Compilation of Key Documents Pertaining to the
Structural Evaluation of
Seabrook Nuclear Power Plant

PROF. VICTOR E. SAOUMA
University of Colorado, Boulder

C-10 RESEARCH AND EDUCATION FOUNDATION
Newburyport, MA

This documents contains the major submittal by C-10 to the Nuclear Regulatory Commission (NRC) in connection with the contested license renewal of *Seabrook Station Unit No. 1 Issuance of Amendment No. 159 Re: Methodology for Analysis of Seismic Category I Structures With Concrete Affected by Alkali-Silica Reaction (CAC NO. MF8260; EPID L-2016-LLA-0007)*¹ that is known to suffer from Alkali Aggregate Reaction² Additional related documents can be found [here](#).

Figure 1.3: Representativeness of the FSEL tests

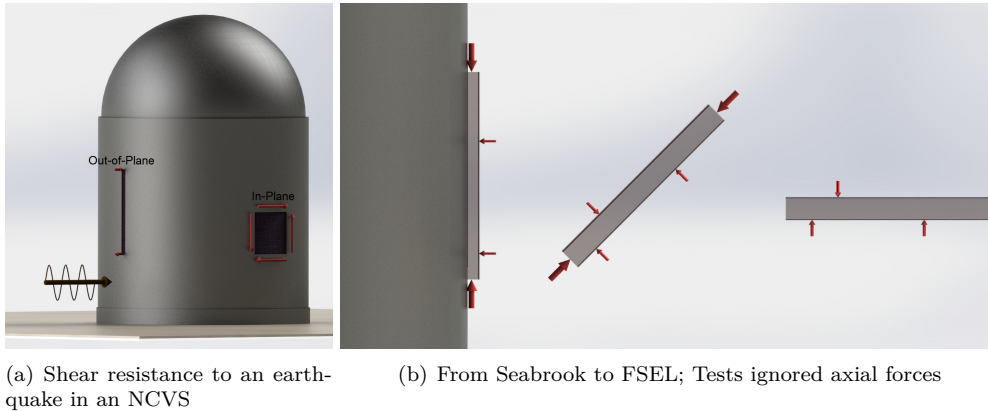
1. What is at stake is the response of the NCVS when subjected to a **lateral seismic load** (ground motion). This will subject it to shear forces that must be resisted.
2. The (cylindrical) container will resist shear through two mechanisms: a) **Out of plane** shear at the azimuth along the earthquake; b) **in plane** shear at 90 degrees; and c) a combination of the two in between, Fig. 1.3(a).
3. In both cases, relevant concrete tests should subject their specimens to large **normal compressive stresses** caused by the weight of the dome and wall above the lower portion of the cylinder (where shear is highest, Fig. 1.3(b)).

Limited Applicability Only out of plane shear tests were performed (Fig. 1.3(a)). Even setting aside the questionable applicability of these tests results, they are only applicable in a narrow zone of the NCVS, Fig. 1.3(a).

Figure 1.4: Some problematic observations

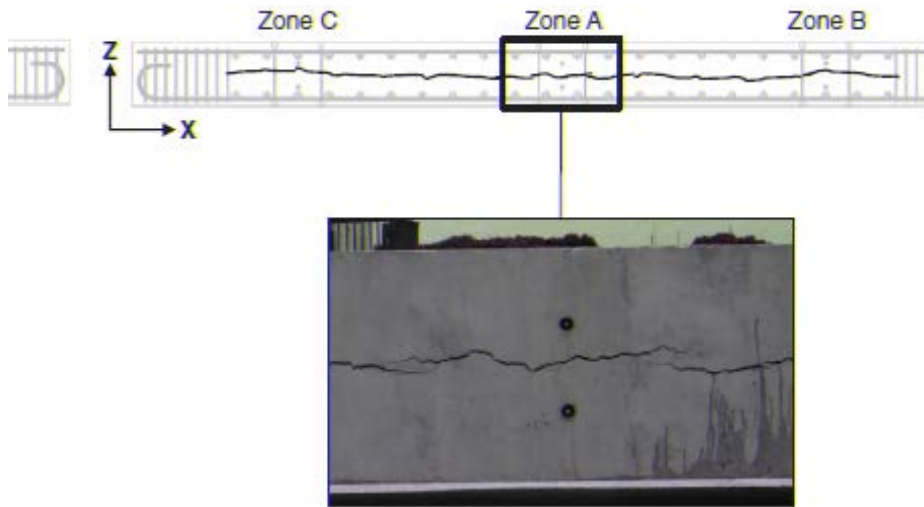
Observed Crack As ASR developed in the test specimens, a large crack was noted in the center of the surfaces of the beam that were between the reinforcement mats. Figure 4-2 is a photograph, Fig. 2, showing the large crack in one of the beam specimens, (**MPR-4288**). This unanticipated large crack on specimen edge (**MPR-Tests-2**) is of major concern. Though mentioned in the report, there is no explanation as to what may have caused it, nor the possible impact it could have on the test results.

Figure 2.5: “Shear” crack formation locations and corresponding load displacement response; Test probably was intended to have a crack in the top figure (green), but ended up occurring in the location shown below (red).

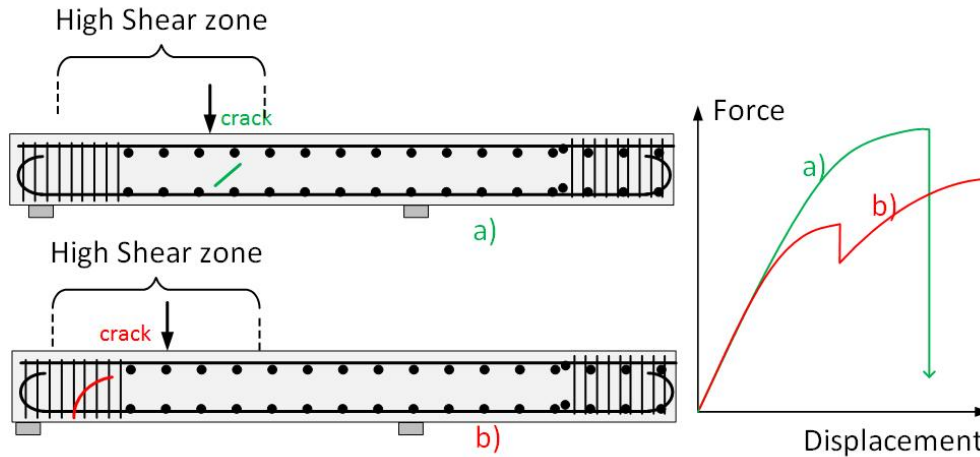
What is likely to have occurred is a crack in the zone of the beam with the shear reinforcement (as shown in Figure 2.5-b) which would cause a load displacement curve as the one reported. Thus, there is a very strong suspicion that shear did not occur where it was supposed to be, but in a reinforced region. Hence there was NO SHEAR FAILURE as intended.

Figure 2.8: Reported Large Crack from Surface between Reinforcement Mats (wald2017expansion)

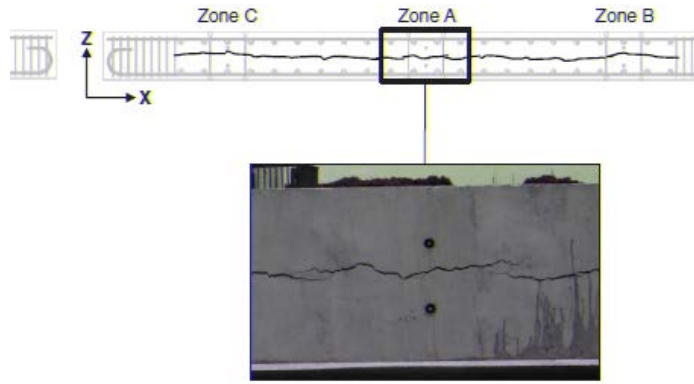
Such an unanticipated crack, shown in Figure 2.8, should be of the utmost concern as it jeopardizes the representativeness of the ensuing test.

Figure 2.13: Progression of ASR and likelihood of being captured by CCI

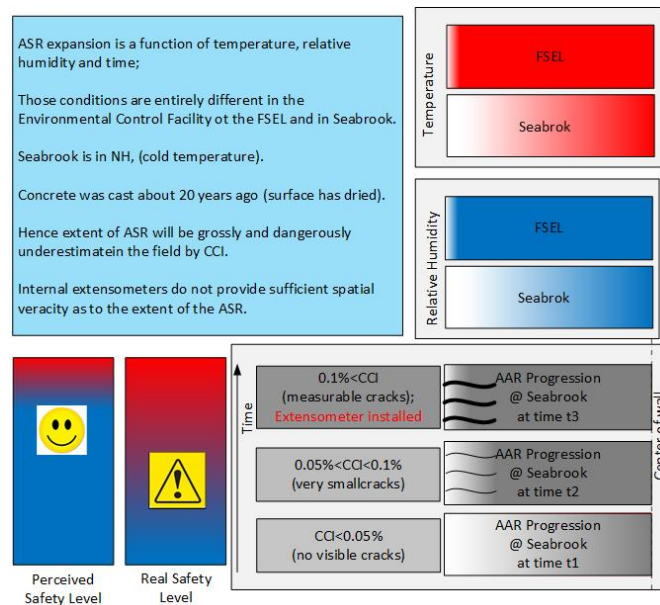
Hence, should cracking be noticeable (through the CCI), that would imply that the internal swelling (where the RH is higher than 80%) was so great that it affected the surface cracking. By the time extensometers are installed, it may already be too late, Figure 2.13.

Figure 2.16: Concerns about finite element analyses

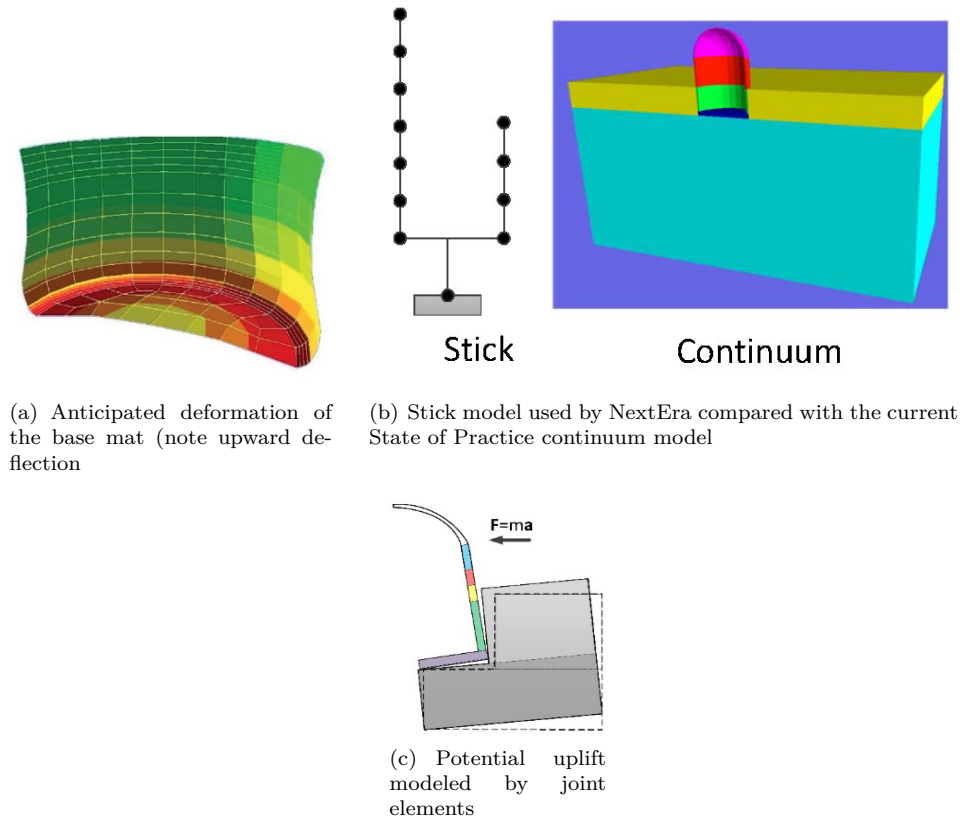
Again, the stick model is a model of the past when computers did not have sufficient capability to handle the time history analysis of a 3D model, Figure 2.16(b). The stick model is overly simplistic, as discussed in the quote below:

Furthermore, stick model cannot capture the seismic contact between the wall and the adjacent soil unless joint elements are inserted.

Figure 3.3: LSTP is a model test and not a prototype test, there will be a [redacted] reduction in shear strength in Seabrook. Adapted from bentz2005.

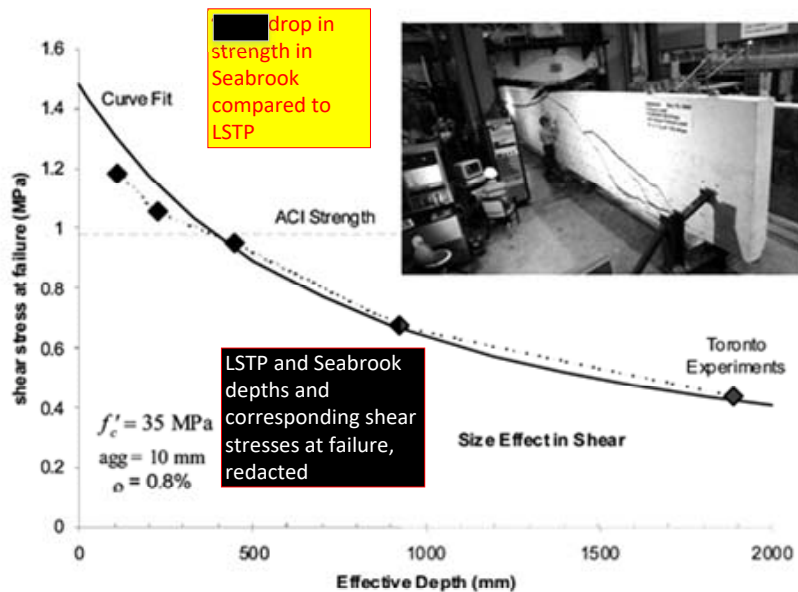
Another important difference between the test specimen and the CEB is that the test specimen was about [redacted] scale ([redacted] depth whereas the wall of a CEB is about 36 inches). This is not unusual in component testing. However, given the brittle nature of shear failure and associated size effect, the shear strength in the CEB will be lower than the one from the LSTP. This phenomenon is described by Figure 3.3, a depiction of the LSTP derived from bentz2005.

Figure 3.8: Possible scenario of internal cracks formation and unlikelihood of being captured in time by CI readings

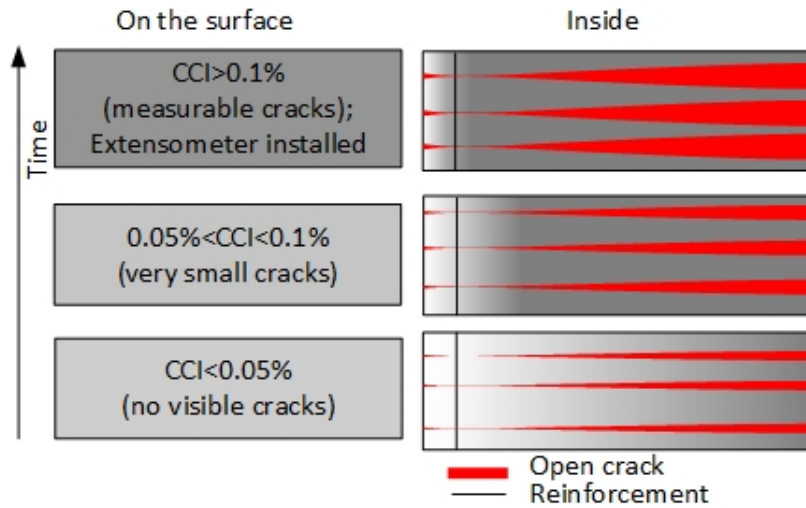
words the reinforcement will “pinch” the crack and the opening on the surface will be much smaller than on the inside). This is further by illustrated in Figure 3.8 (where the crack opening is in red)

In light of the above, I continue to insist that the expansion inside Seabrook CEB is almost certain to be much higher than what can be recorded by CI.

Figure 3.10: a) Finite element model analyzed to duplicate pre-test cracks (adapted from (wald2017expansion)); and b) adopted cohesive crack model

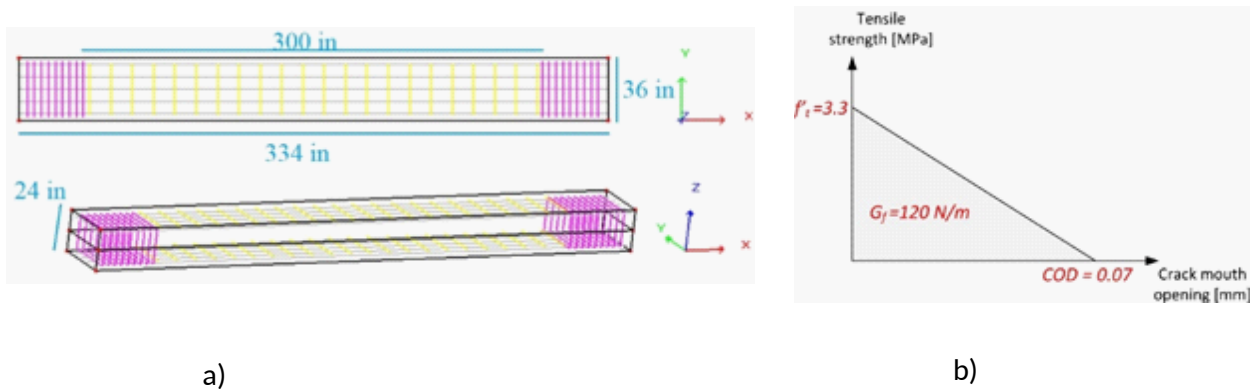
Hence, to better understand what has happened a nonlinear 3D fracture mechanics based finite element analysis of the tested beam was conducted (Figure 3.10), Results are summarized below

1. Because of unconstrained vertical expansion, indeed a crack formed in the portion of the beam that is without shear reinforcement (stirrups) as shown in Figure 3.11. This matches the crack observed in the LSTP, Figure 3.13.
2. At midspan, the computed crack profile is shown in Figure 3.12. It matches what has been reported by NextEra that is the crack opening is largest on the edge. We estimated it to be 1.4 mm (this may be less than what was determined, but again in the absence of tests we had to estimate the fracture energy GF).

Figure 3.15: Very likely delamination mechanism inside Seabrook

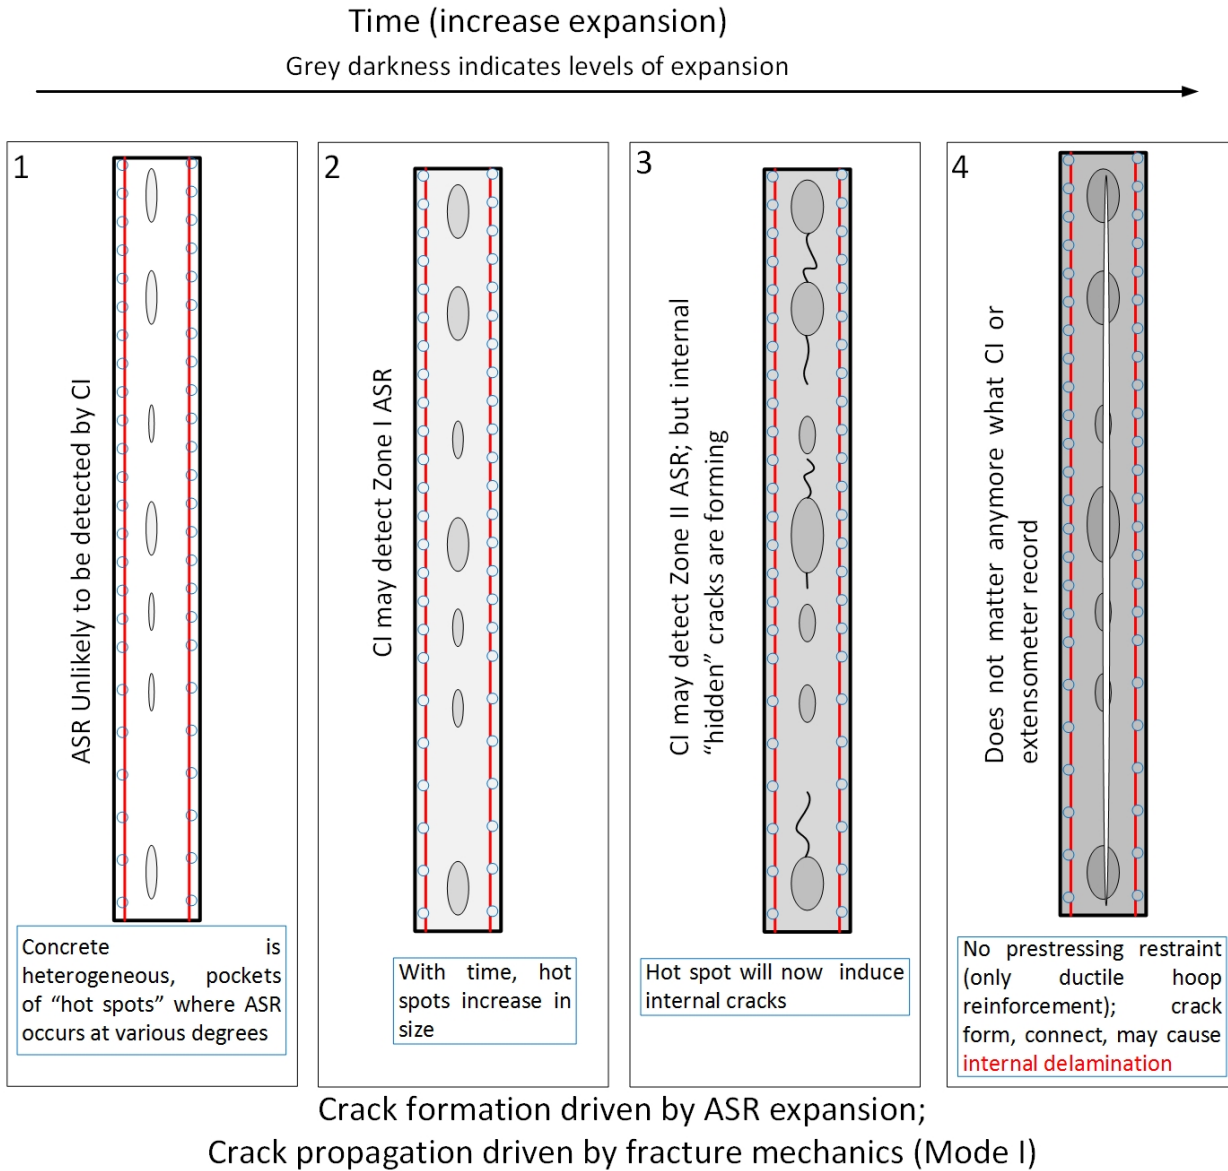
- 6. At some point, those cracks will coalesce (i.e. inter-connect) causing internal delamination, Figure 3.15. This will be an internal structural crack, causing delamination (through the very same mechanism that caused the cracking of the shear beam even before being tested, with the additional complication of having a compressive stress that will dope it even more). This delamination will severely weaken the CEB. Most importantly:

Figure 3.22: Uncertainty in the determination of the Elastic modulus from the compressive strength as proposed by NextEra [PROPRIETARY INFORMATION]

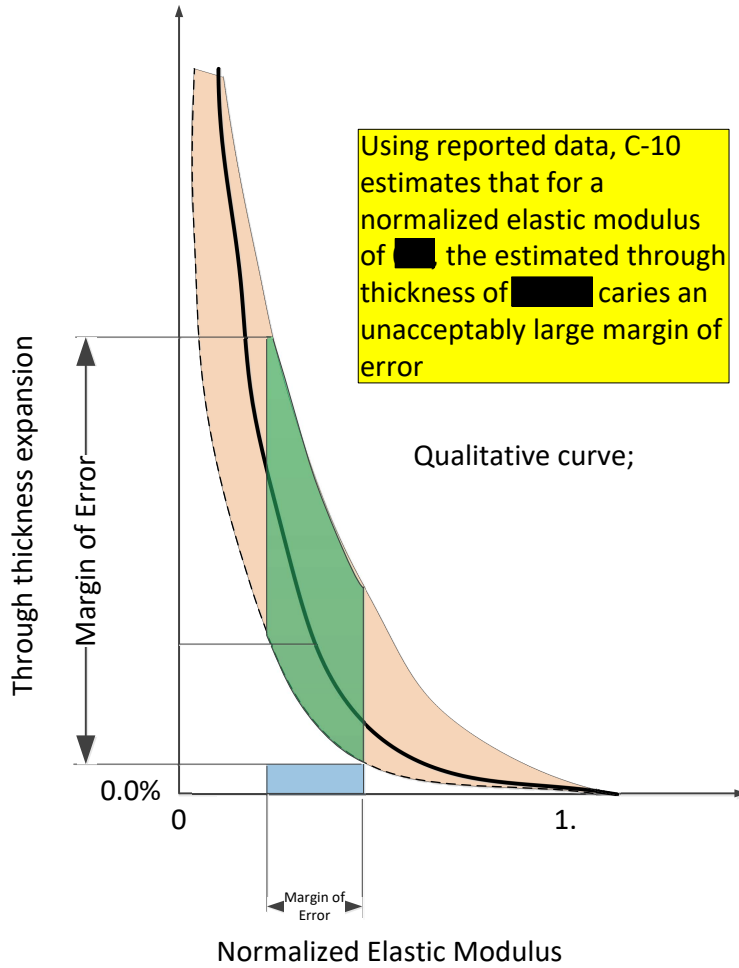
I analyzed the impact of both uncertainties, Figure 3.19 and Figure 3.20 to determine what would be the possible margin of error in NextEra’s curve (shown in Figure 3.21). The result is shown in Figure 3.22. The approach is described next:

7. In Figure 3.22 we go up the y axis to determine the through thickness, and note that it would be somewhere between █████% and █████%.

Figure 4.2: Impact of ignoring the concrete strength increase over time.

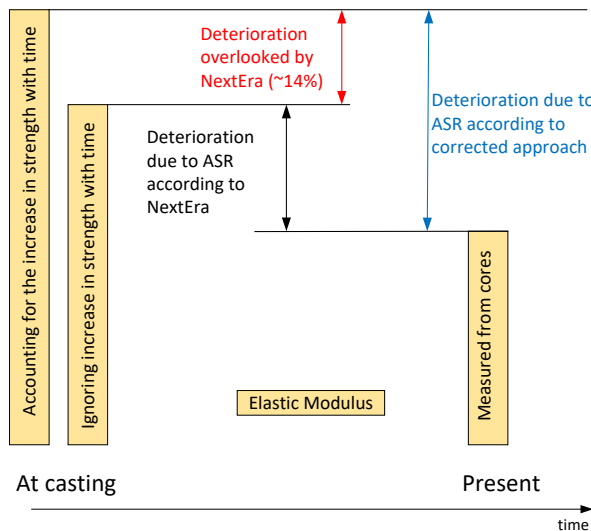
The impact of NextEra’s and MPR’s oversight is further illustrated in Figure 4.2 below. Taking into consideration the increase in compressive strength during the first two years after casting the Seabrook concrete, the actual amount that compressive strength has been lost due to ASR will be substantially more than the loss estimated by NextEra and MPR using the corroboration study in its current form. In other words, the extent to which ASR has damaged the concrete at Seabrook will be much greater than the extent that will be estimated by MPR’s method. Hence, the corroboration study will not yield meaningful results if it fails to account for the fact that the compressive strength of Seabrook concrete was initially much greater than assumed.

Figure 4.3: Adjusted relationship between through-thickness expansion and the corrected normalized elastic modulus

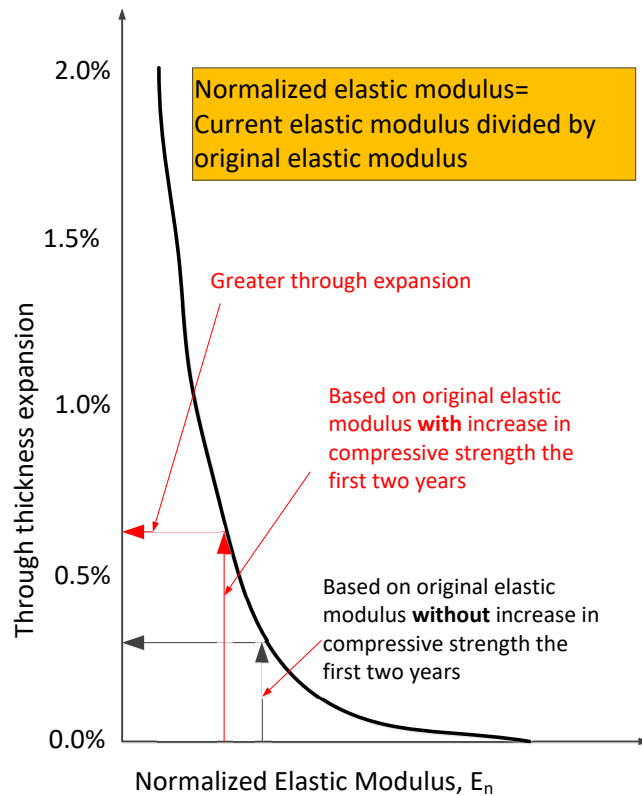
This new information about the increase in compressive strength also affects my original Figure 22 (page 40 of my Rebuttal Testimony). In Figure 4.3 below, I have modified Figure 22 to account for the increase in the compressive strength. The curve for the normalized elastic modulus is shifted to the left, while maintaining the same margin of error. (Note that I have removed the errors bars to facilitate understanding). Because the through thickness is indeed very sensitive to the normalized

elastic modulus (see Figure 21 at page 38 of my Rebuttal Testimony¹), this will result in an even greater through thickness expansion than predicted by NextEra.
